Denton Convention and Visitor Bureau

Visitor Center Signage Plan & Spec's.

TOWER #1 VISITOR INFORMATION SIGNAGE
SIGNAGE ADDITION ELEVATION - SHEET 4B

MESSAGE: L.L. Approved Sign Drwy's. & Specs.
(Revised 8-3-94).

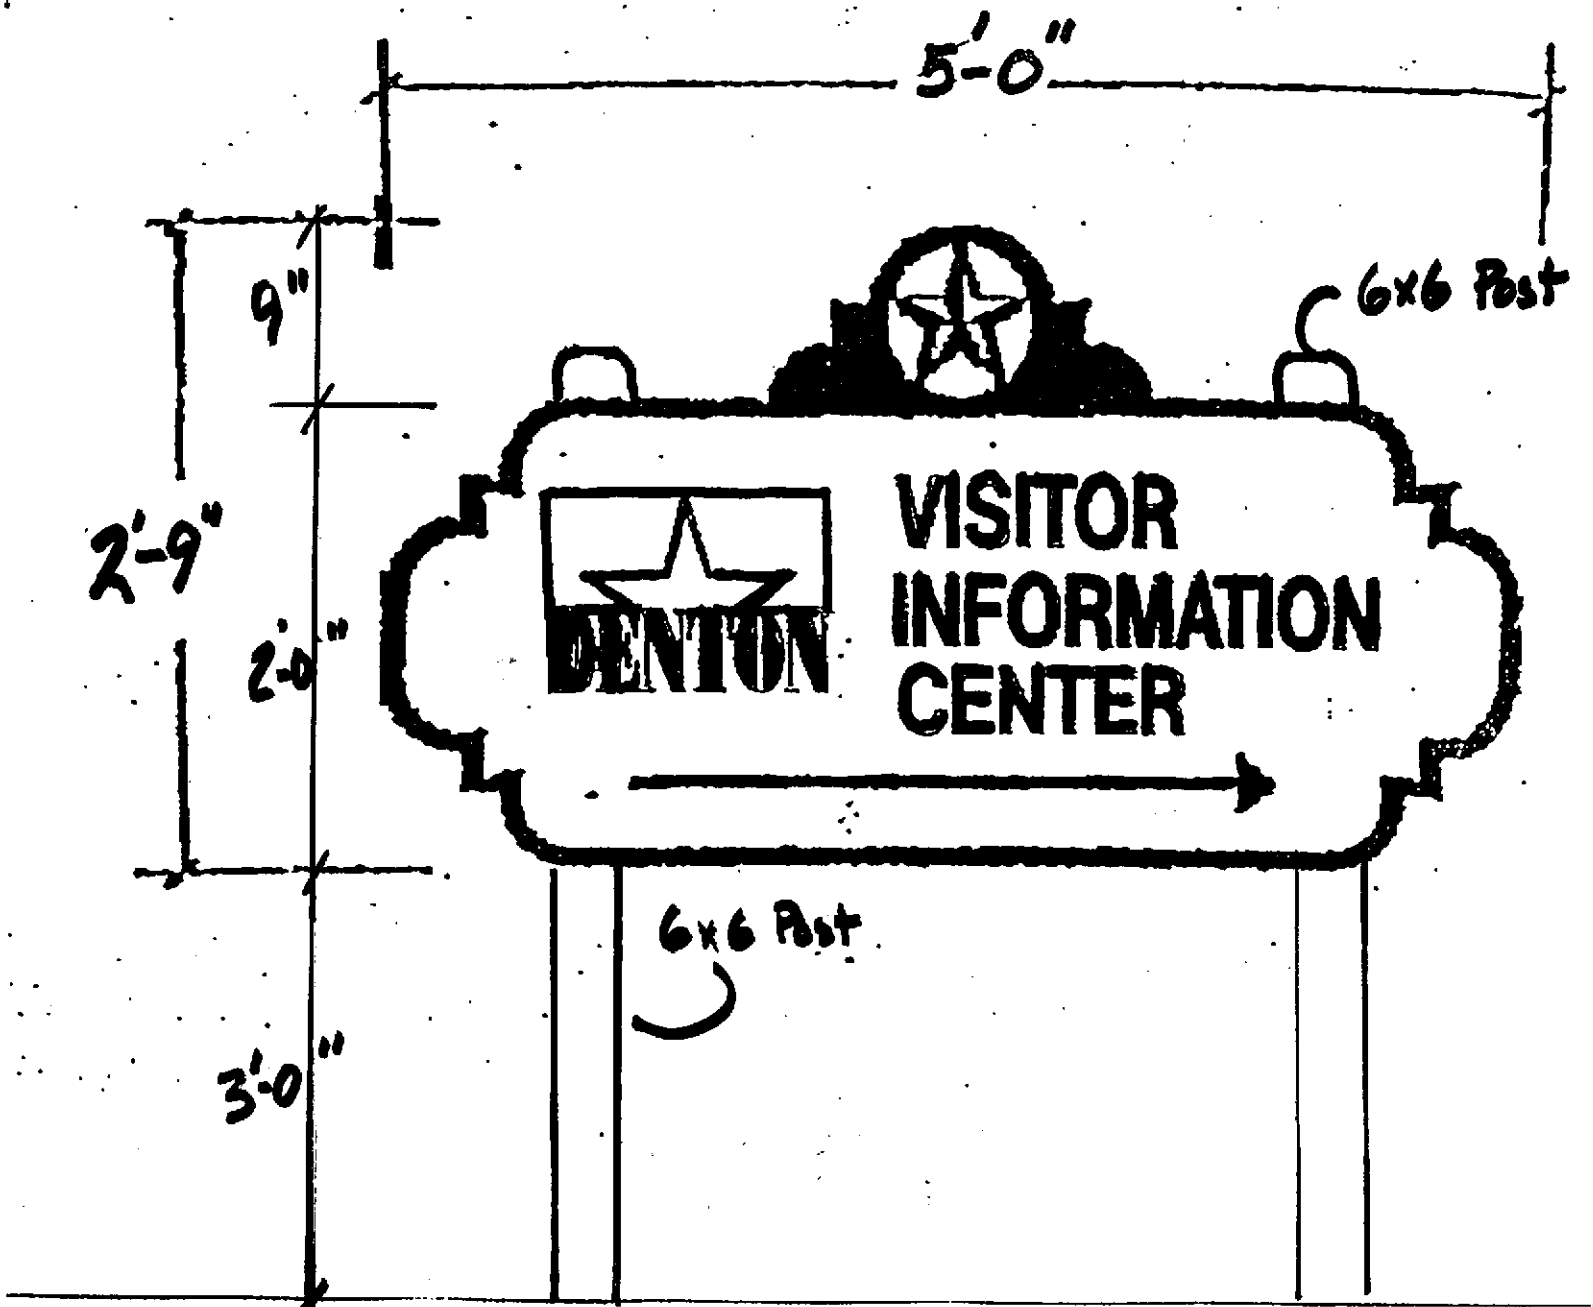
1. See Attachments For Details.
2. Sign Type "A" on Hold pending review of state furnished directional sign

B&C

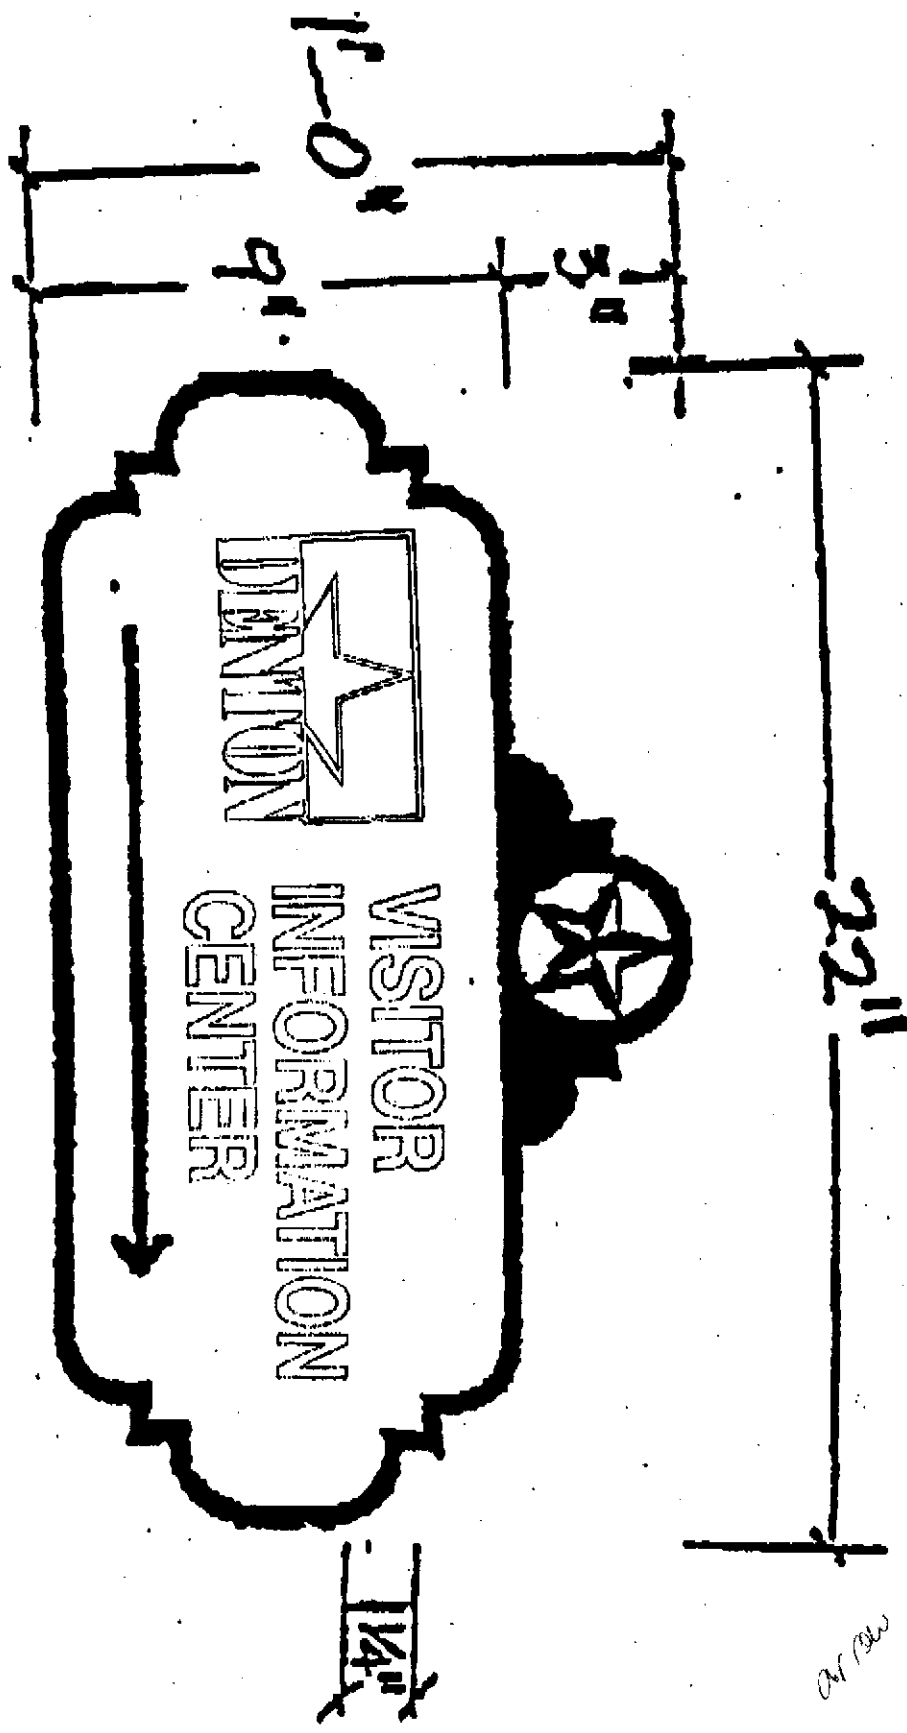
Color
LAYOUT
OK.

TOWER #1 VISITOR INFORMATION SIGNAGE
SIGNAGE ADDITION ELEVATION - SHEET 4B

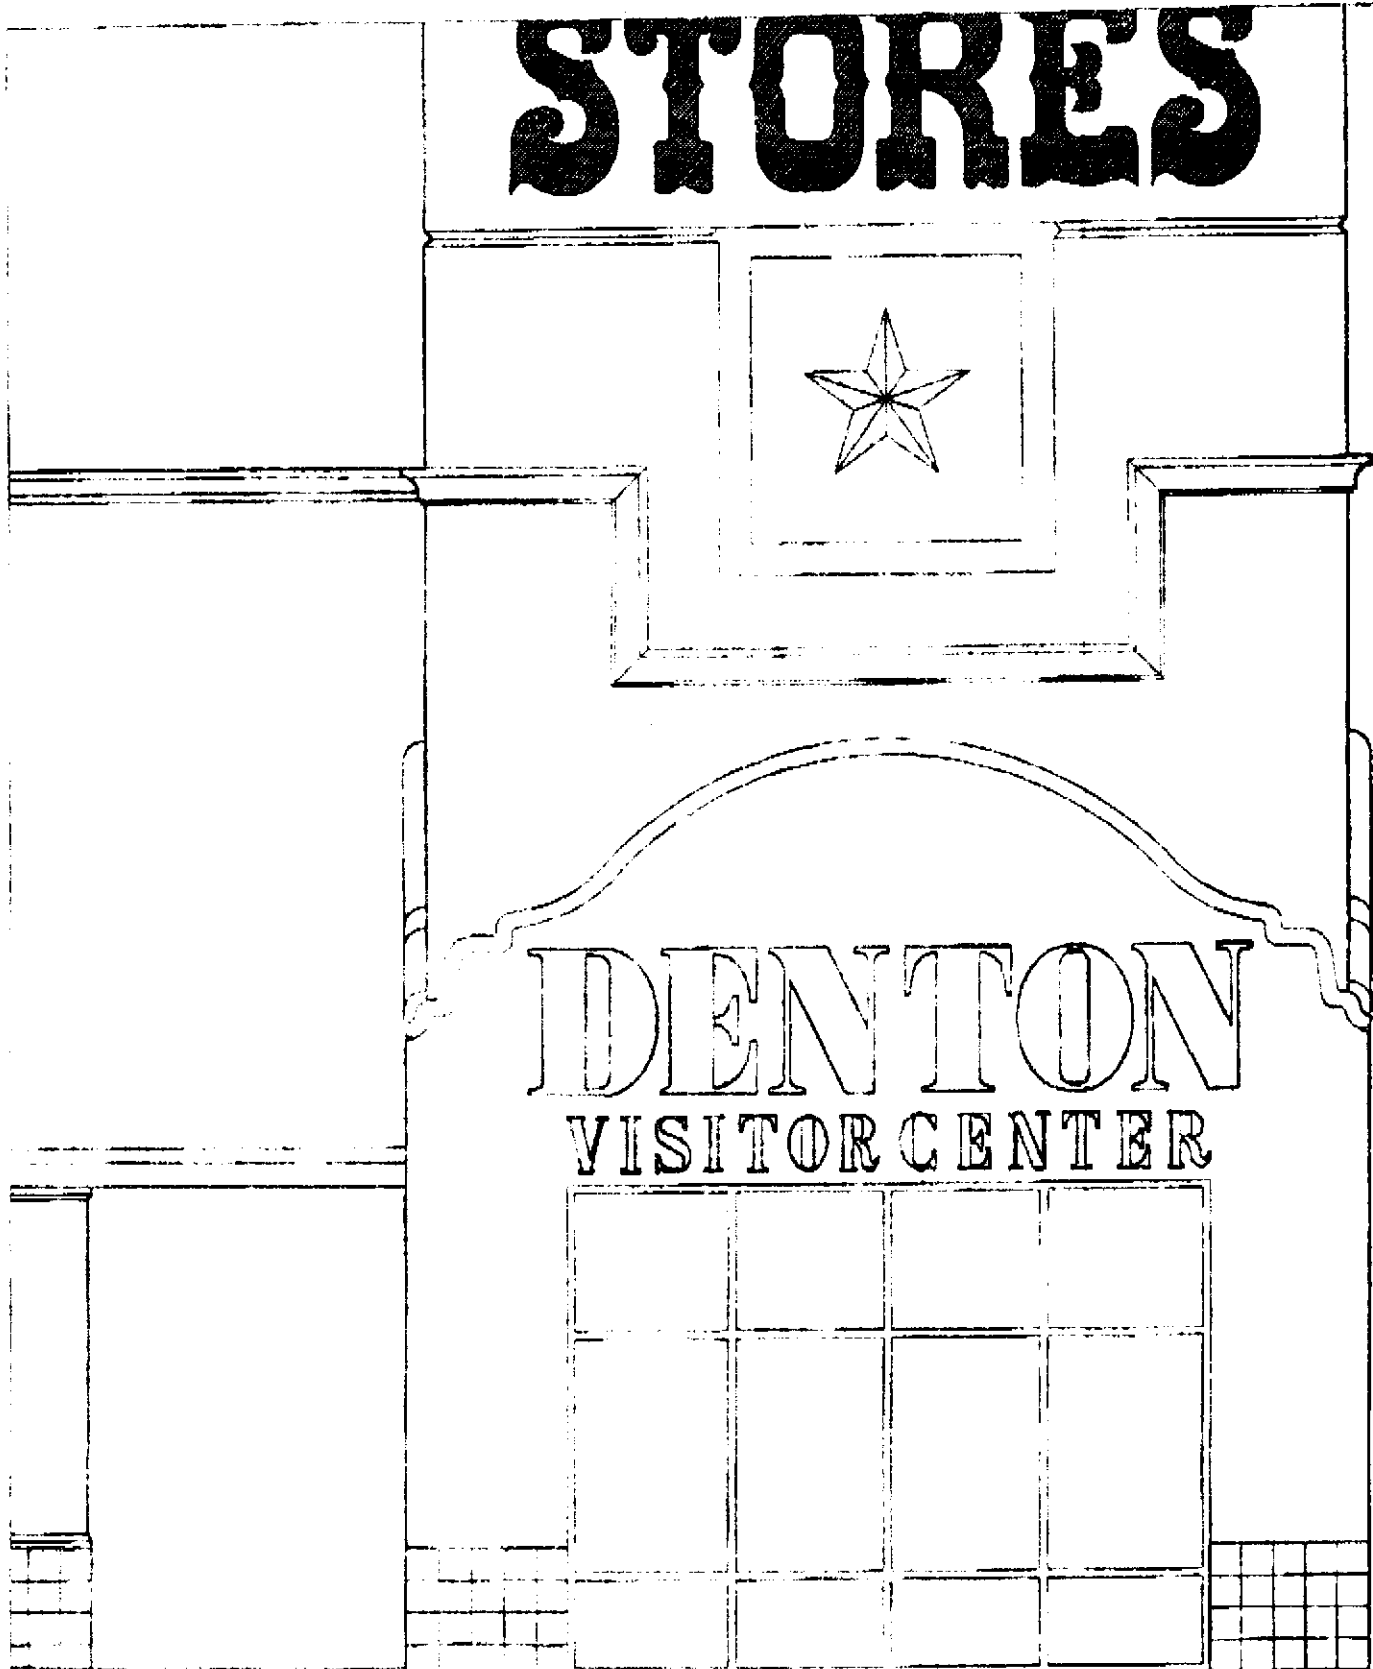
Sign Proposal was approved. Call him on his mobil phone.

Will fax approval and final
art for sign (enlarged
by architect).
